UNITED STATES PATENT AND TRADEMARK OFFICE

APPLICATION NO.	FILING DATE	FIRST NAMED INVENTOR	ATTORNEY DOCKET NO.	CONFIRMATION NO.
10/716,483	11/20/2003	Nicolas Roux	245510US41X DIV	6694

Office Action Summary	Application No. 10/716,483	Applicant(s) ROUX, NICOLAS	
	Examiner Kevin M. Nguyen	Art Unit 2629

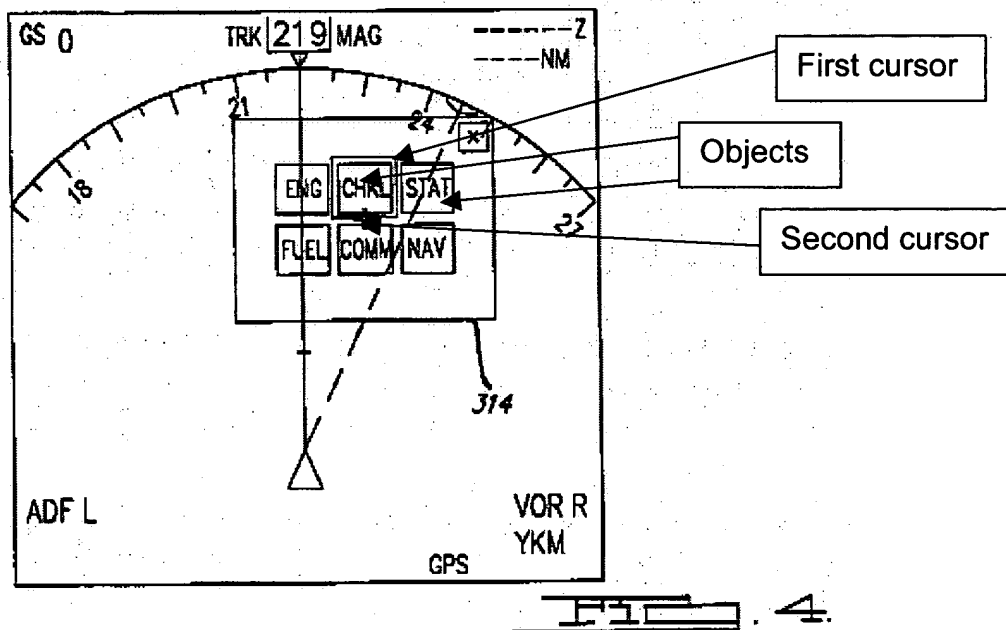
Holding the switch depressed would jump the cursor from display to display to display in the direction shown" see col. 6, lines 26-30. Accordingly, the feature "jump the cursor" corresponds to "moving cursor discretely" as claimed. As indicated the figure 4ⁱ given below, a first cursor corresponds to an auxiliary cursor, which moves discretely from one responsive object to another responsive object as recited claims 1 and 12 (see col. 5, lines 29-50 for further details of the explanation).
